37/03-06HHH 57 WALNUT AVE

Takoma Park Historic District

STAFF ITEM

SUBJECT: Revision to approved HAWP (HPC Case No. 37/03-06HHH), for window replacement and siding removal, at 57 Walnut Avenue, Takoma Park, within the **Takoma Park Historic District**

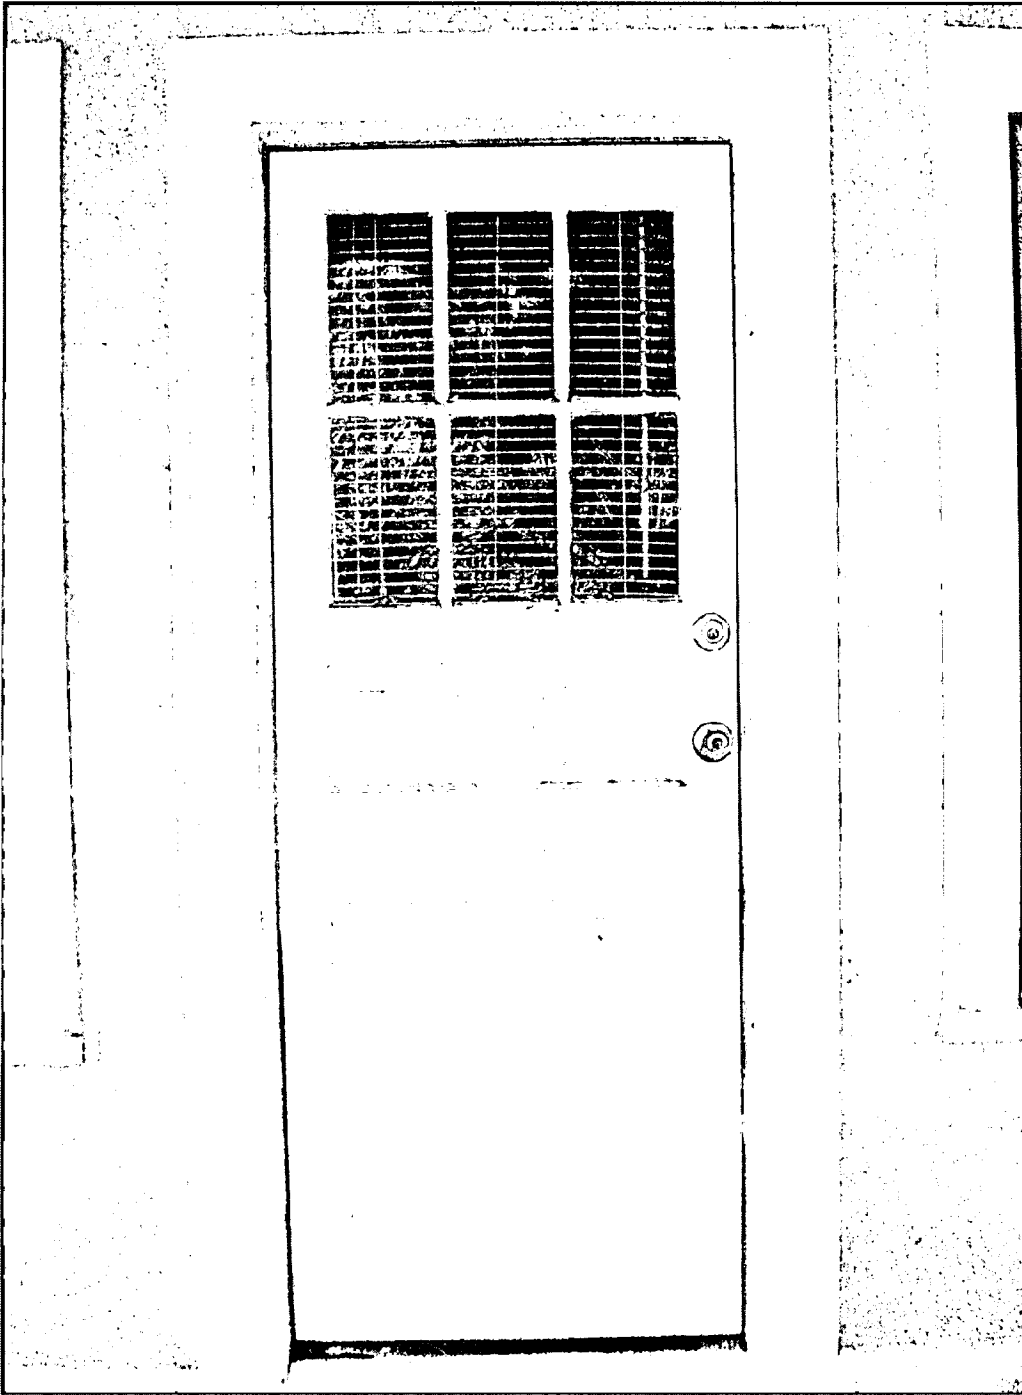
- 1.) Front elevation, far right (2) windows: Consistent with the HPC approval the 2 right side front elevation windows need to be True Divided Light, 6/1, wooden (interior/exterior) windows to match the existing original windows on the front elevation.

We plan on installing a full view storm door, in white, to prevent further weathering to the original front door.

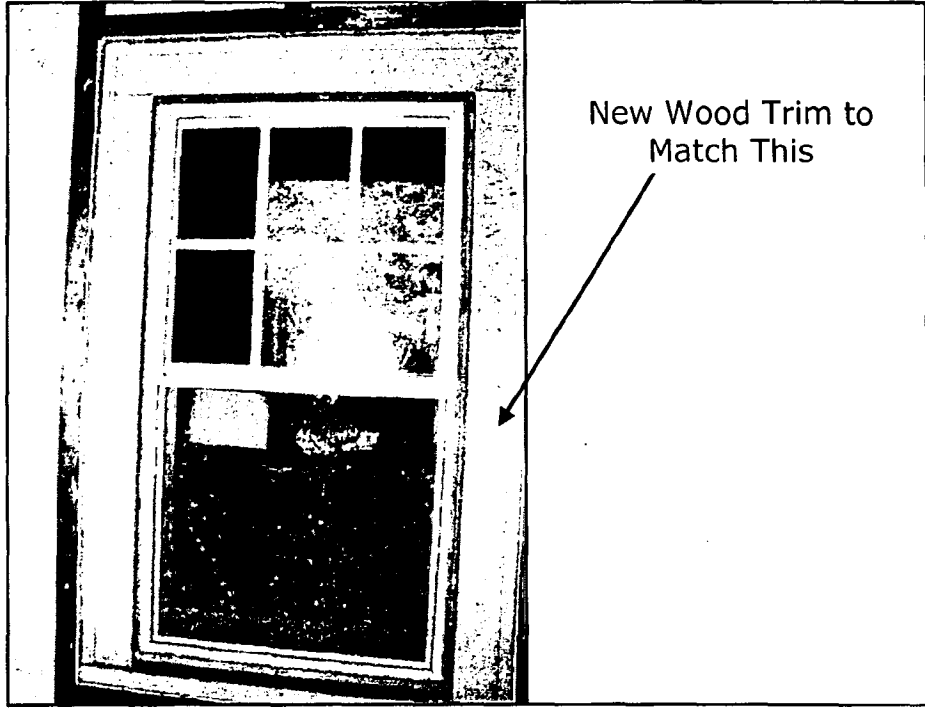
New Wood Trim to Match This

Future Patio Roof in This Location

EXISTING CONDITION

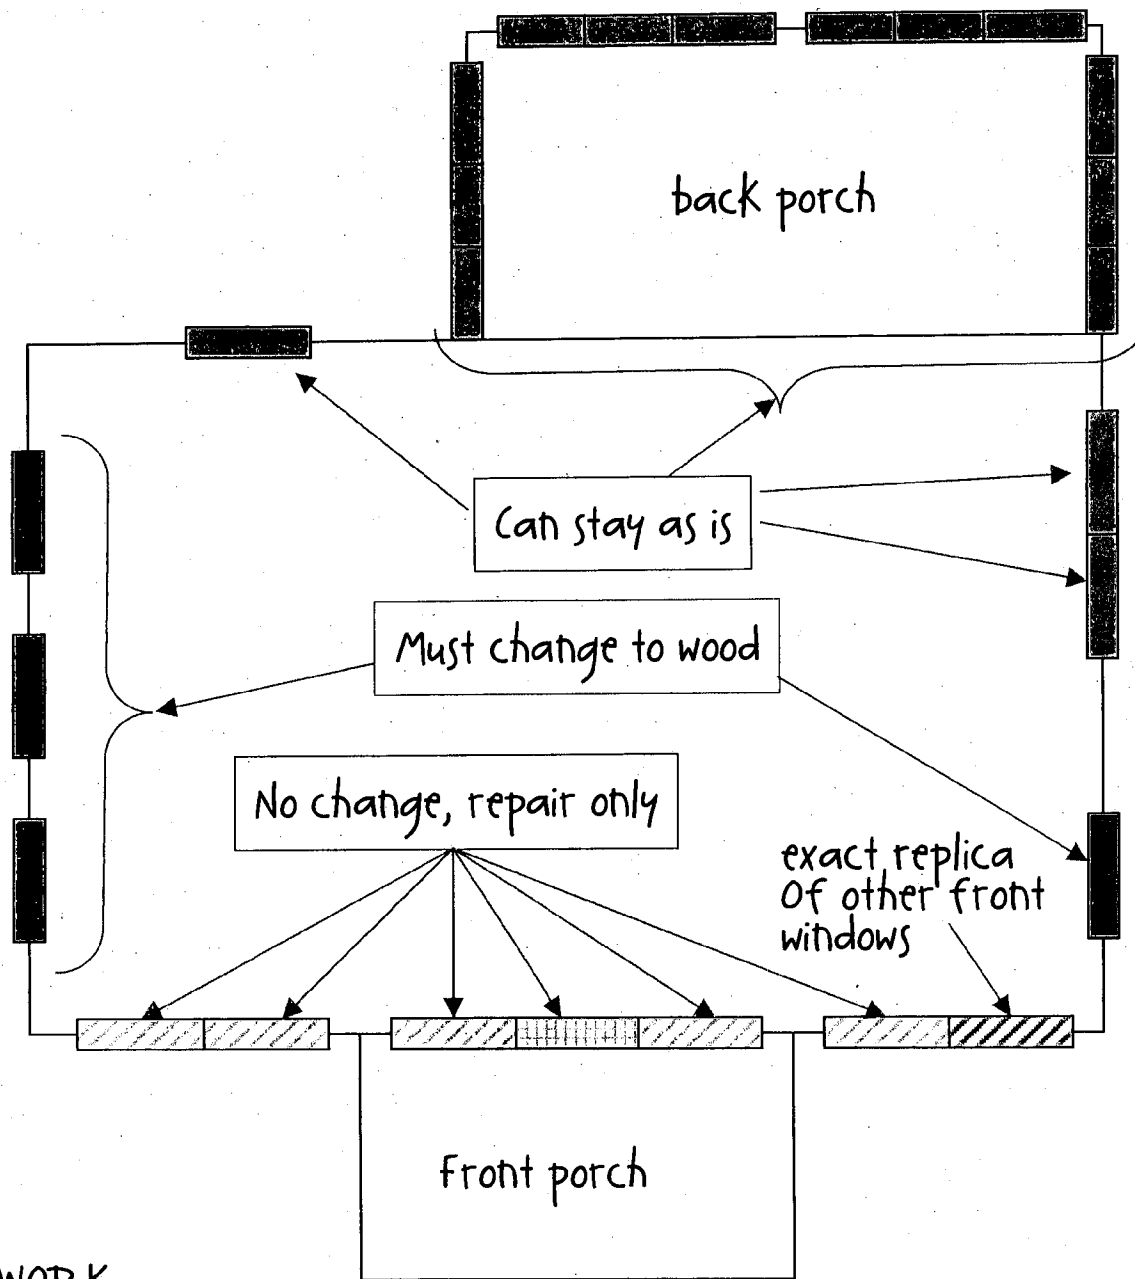
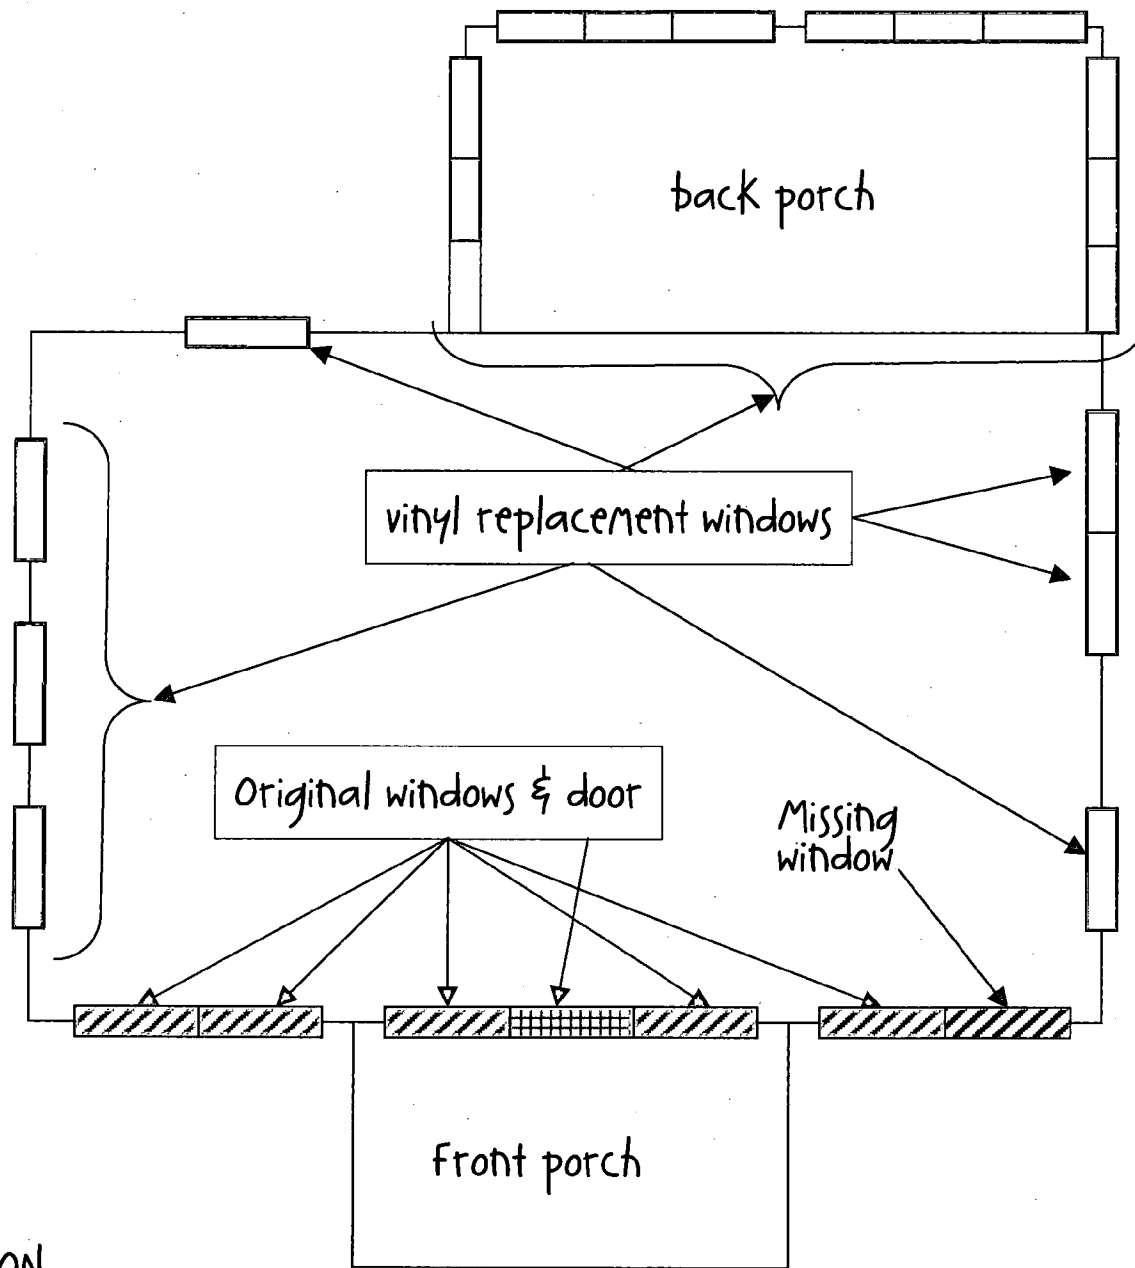
- I would be open to negotiating exactly which ones would need to be replaced with windows that are more appropriate.
- The windows were 6 over 1's which is a relatively easy window type of match reasonably.

- Therefore, I think if we come up with insulated glass and permanently fix --that match. It might be a way to get back closer to the appearance that was there without having to truly replicate --

- Does he need to remove the windows that he installed? For the ones most visible. Correct? Right. Yes, staff understands.
- So if you wish to remove the aluminum siding, you would need to return the house to its historically correct appearance. And that's why I would entertain either stucco or wood.

Remaining Wood Windows – Front Elevation

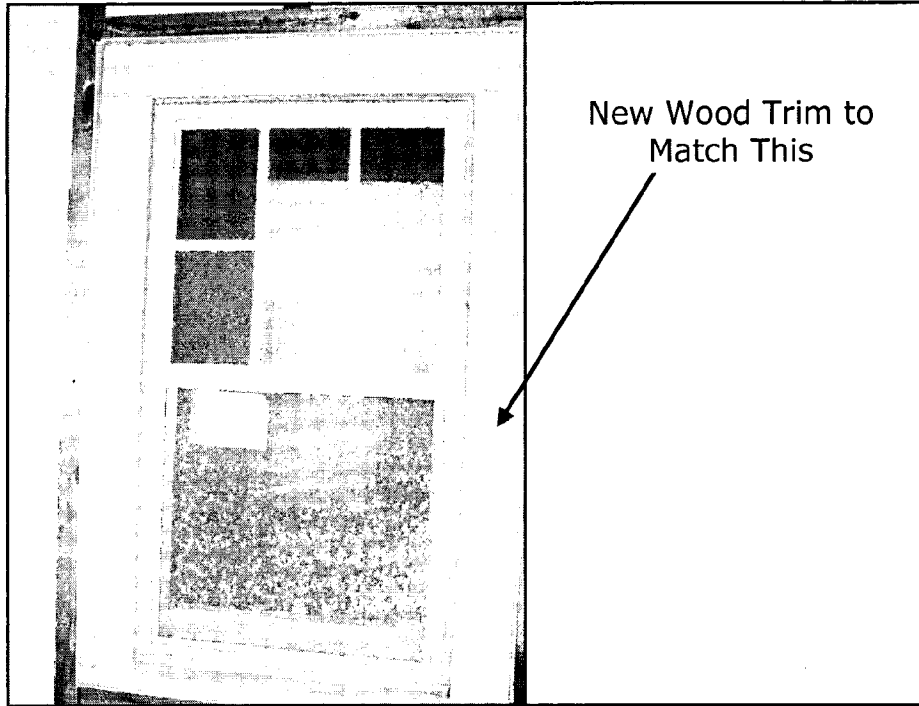
Remove Vinyl
Replacement Windows

Basement Vinyl Replacement
Windows Remain

Future Patio Roof in This Location

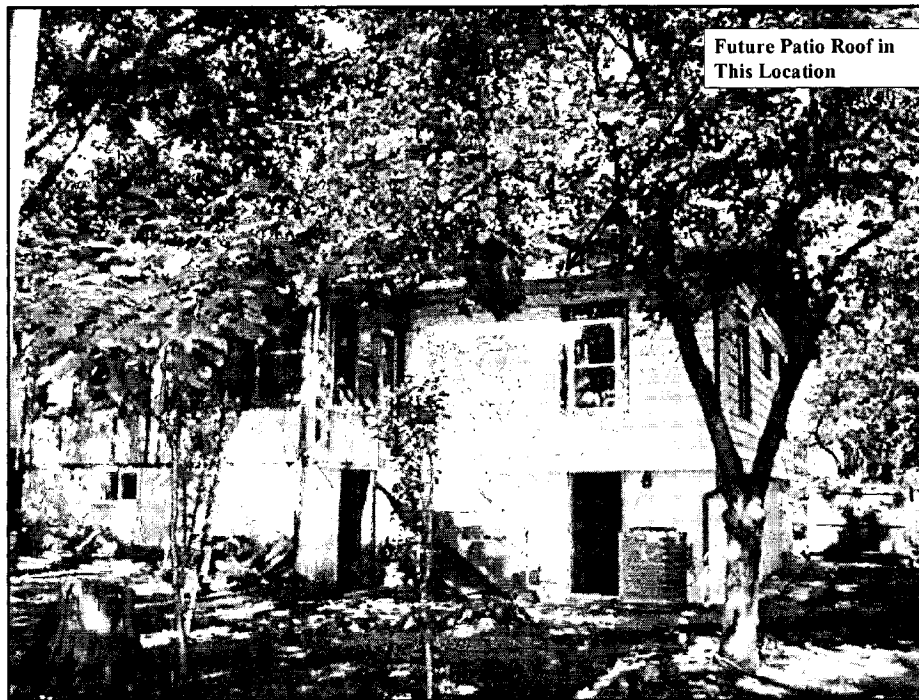
New Wood Trim to Match This

New Wood Trim to Match This
